DRB FILE: #18-0246
REQUEST FOR MODIFICATION TO DRB FILE: #16-0073
802 W DILIDO RESIDENCE

DRB FINAL SUBMITTAL
APRIL 6, 2018

802 W. DILIDO DRIVE

REQUEST FOR MODIFICATION TO
DRB FILE: #16-0073, TO RAISE
GRADE IN SIDE COURTYARDS
+1'-1" ABOVE ADJ. GRADE

NORTH COURTYARD (PROPOSED)

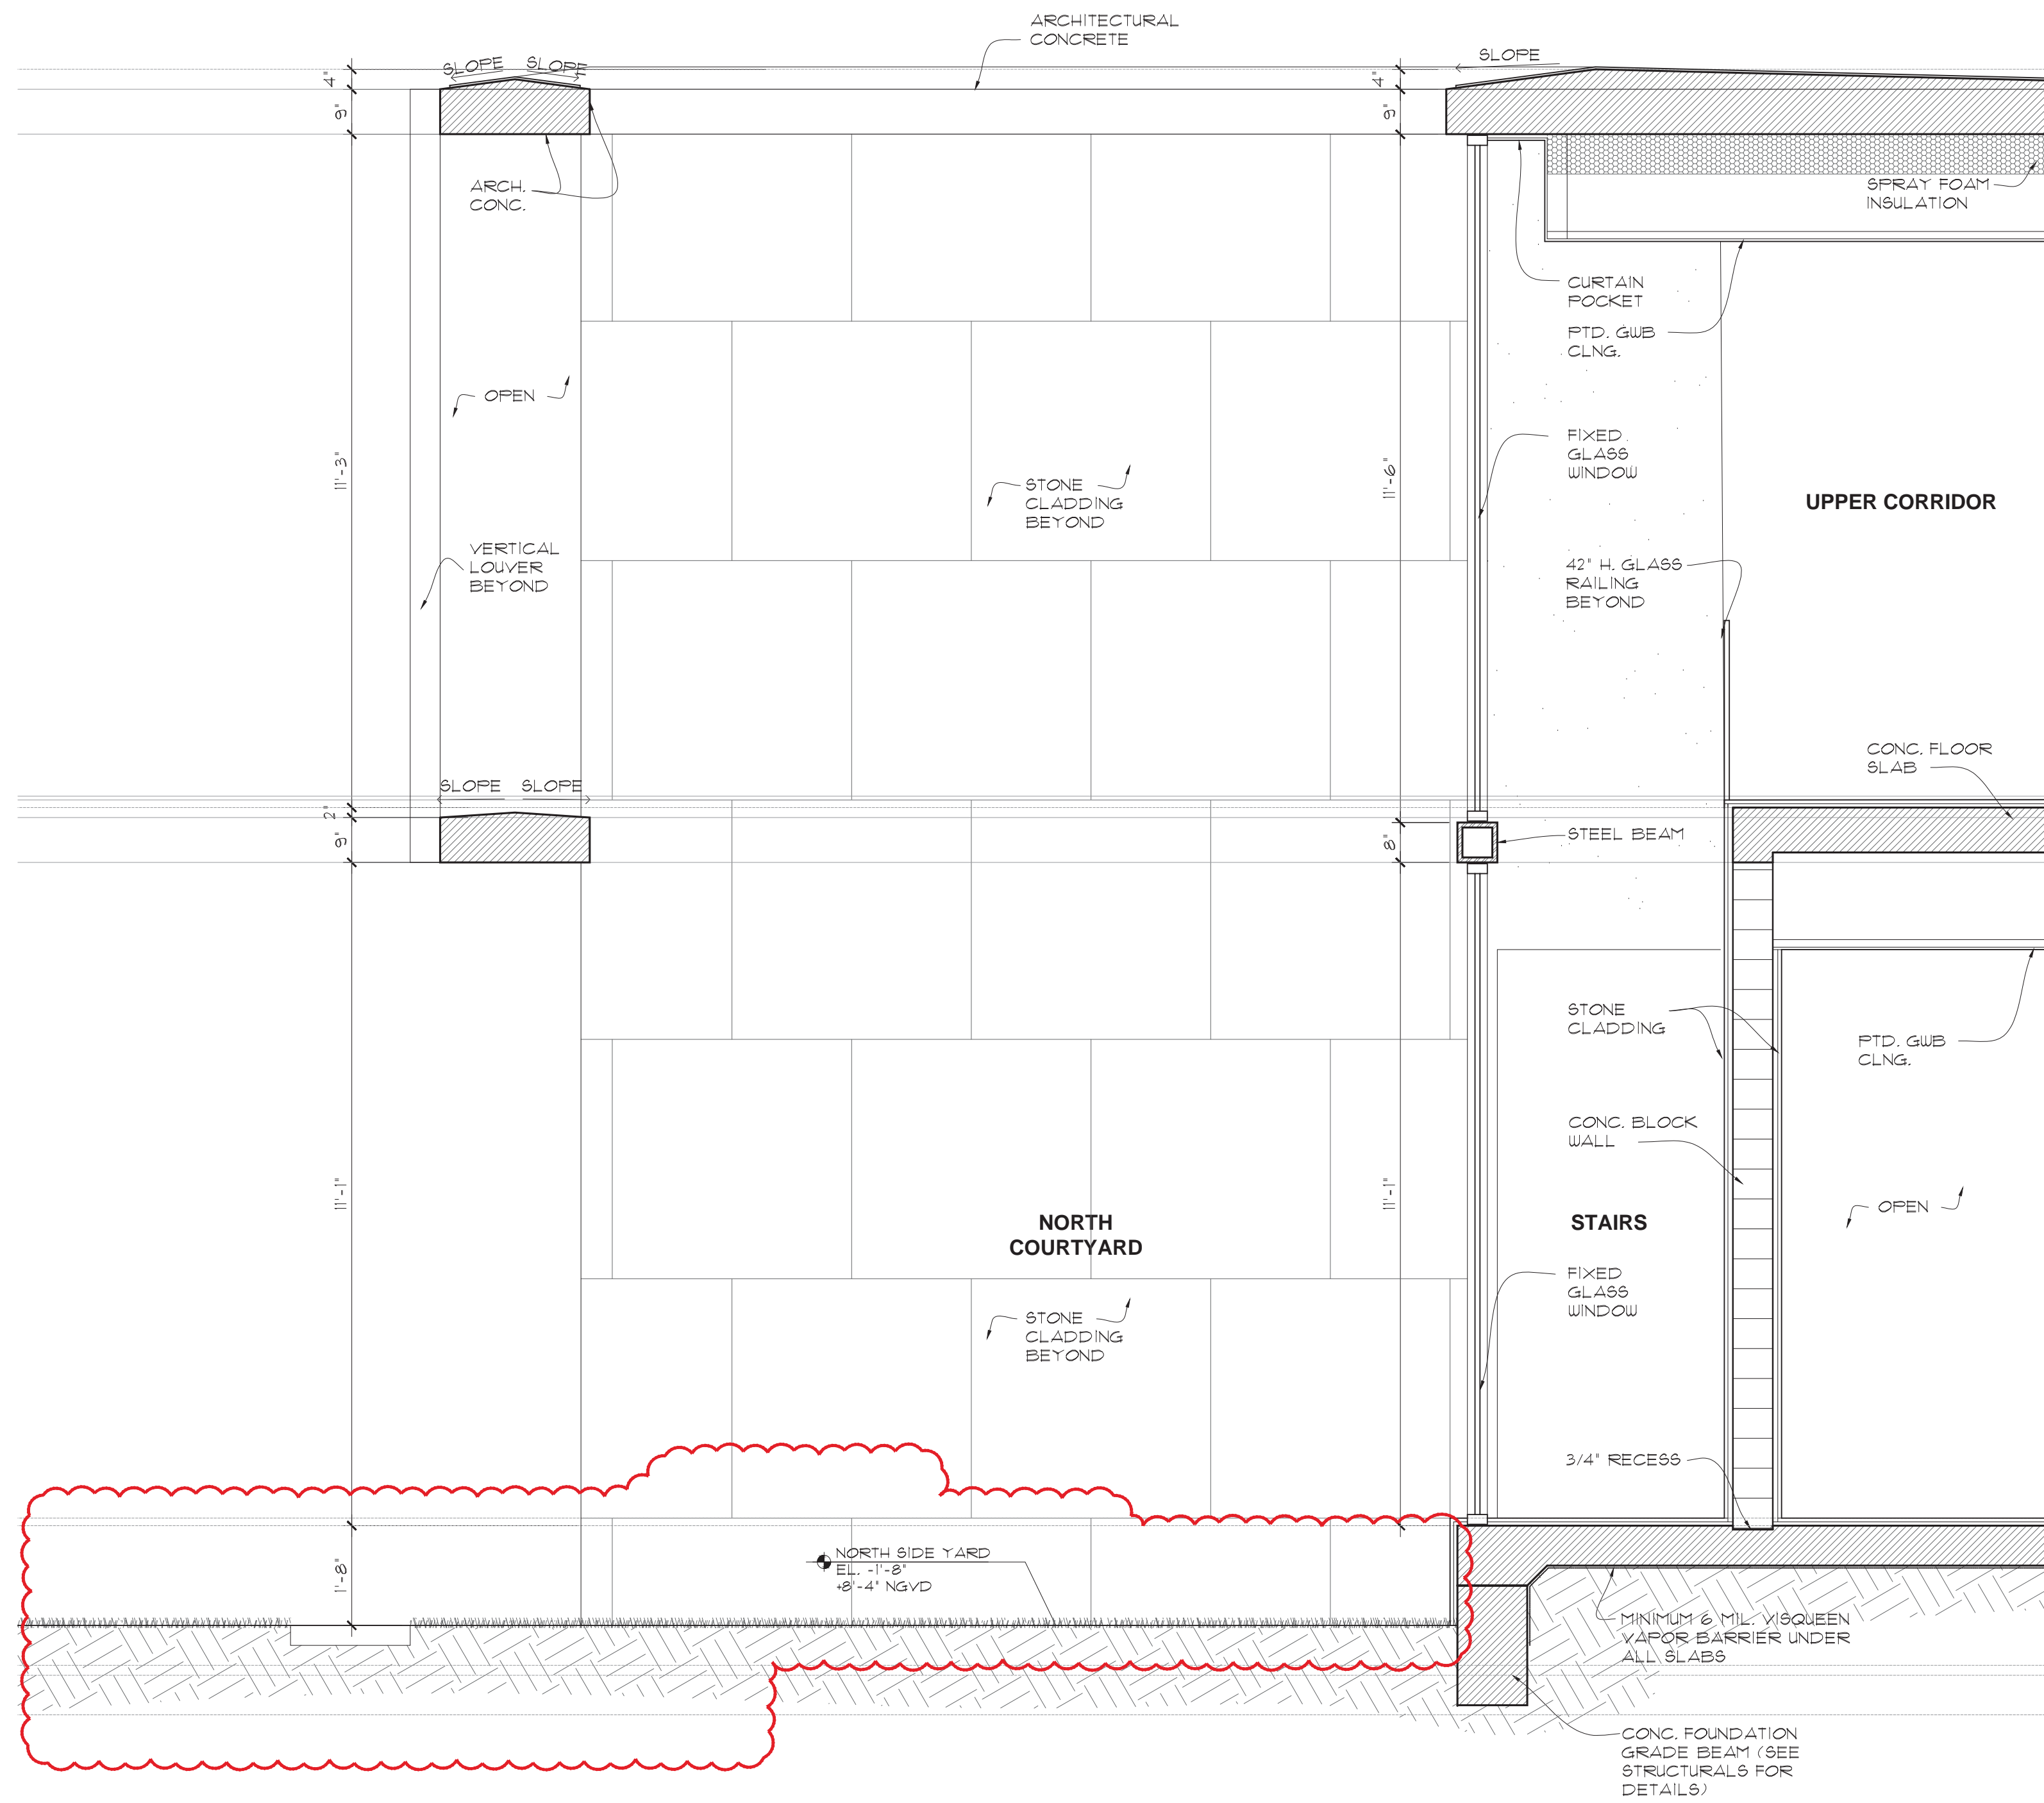
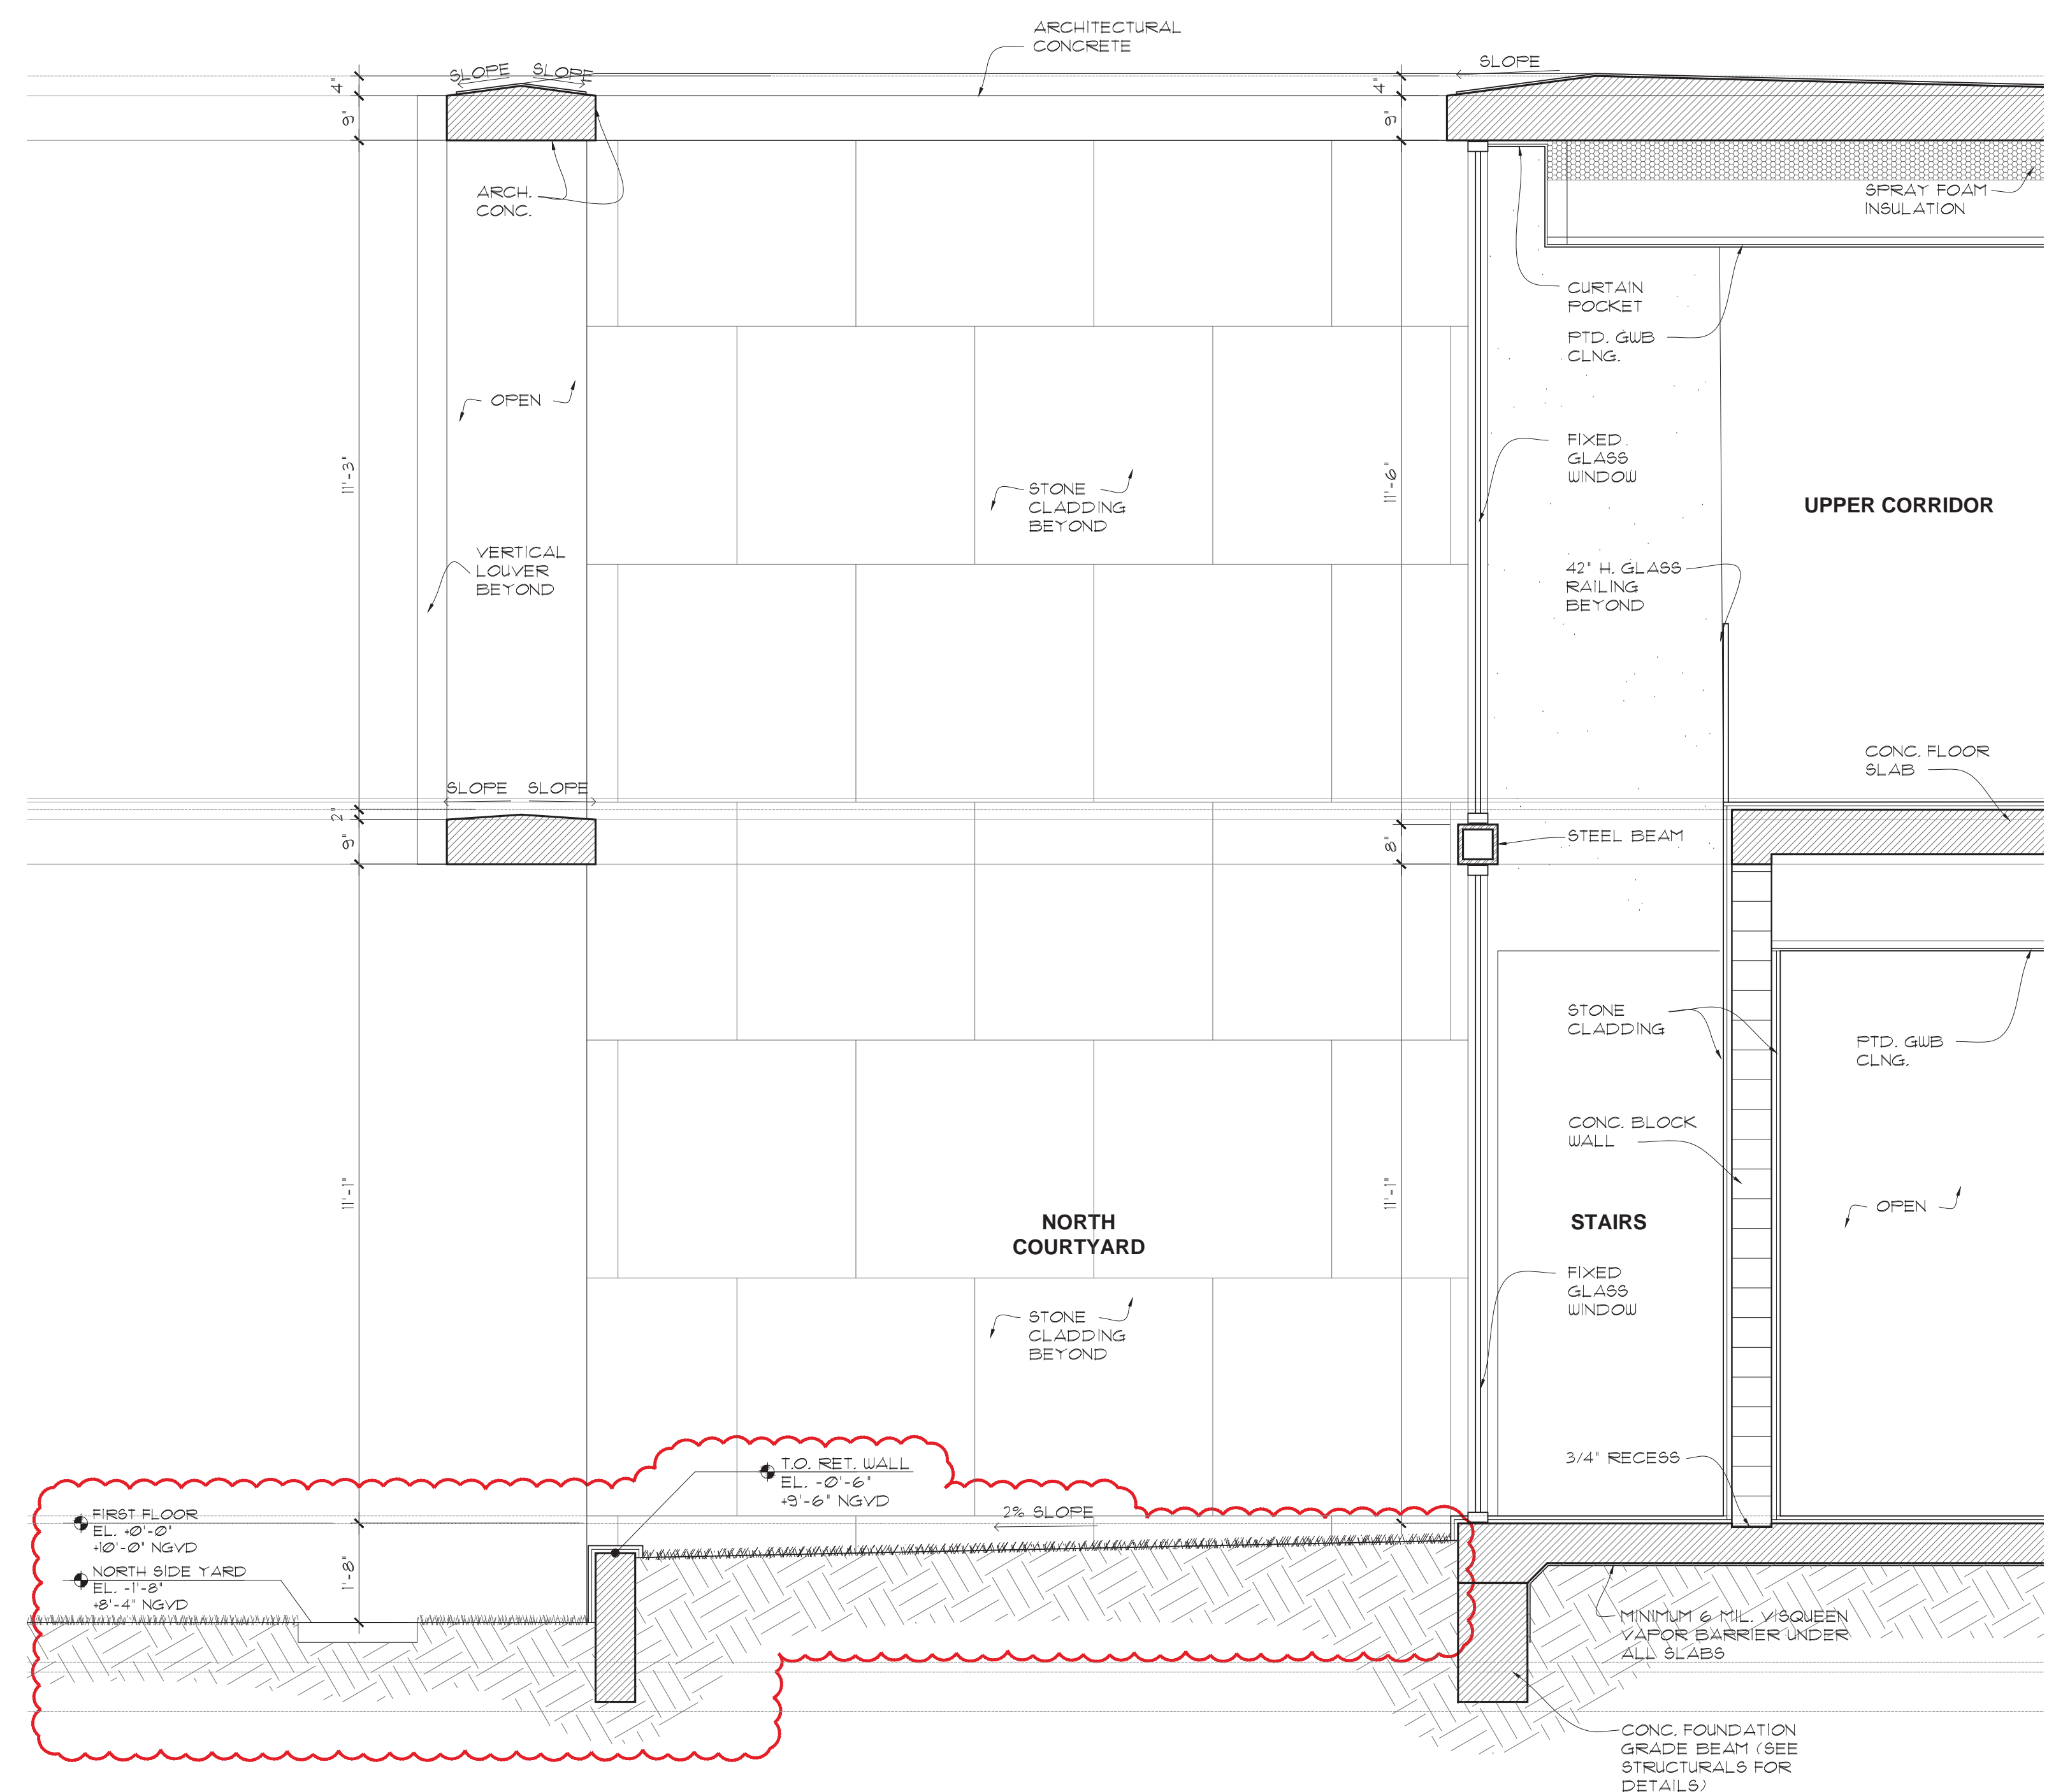
REQUEST FOR MODIFICATION TO
RAISE SIDE COURTYARDS +1'-1"
ABOVE ADJ. GRADE
